BODY BUILDER'S BOOK BULLETIN

DATE:NOVEMBER 2, 2004MODEL YEAR:2003 AND AFTERCHASSIS MODEL:UD1800HD/UD2000/UD2300LP/UD2300DH/UD2600/UD3300BULLETIN NUMBER:BBB-10FILE IN THE TECH. NOTES SECTION OF THE BODY BUILDER'S MANUAL

UD TRUCKS COMPLIANCE WITH FMVSS III REARVIEW MIRRORS

CORRECTED INFORMATION

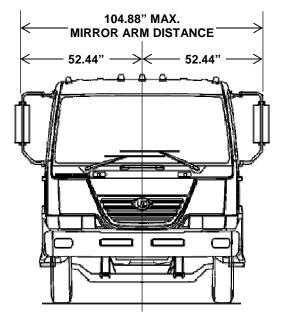
Regarding overall body width, this Document states on Page 10 that "such body shall not exceed 96 inches in overall width nor 48 inches from body side to chassis longitudinal centerline."

Effective with the release of 2006 model year Nissan Diesel Motor Company will change the Document for Incomplete Vehicle to read "such body shall not exceed 102 inches in overall width nor 51 inches from body side to chassis longitudinal centerline."

Diesel America is also stating that 2003 through 2005 model year chassis models listed above may also be equipped with 102 inch overall width body and as such be in compliance with FMVSS 111.
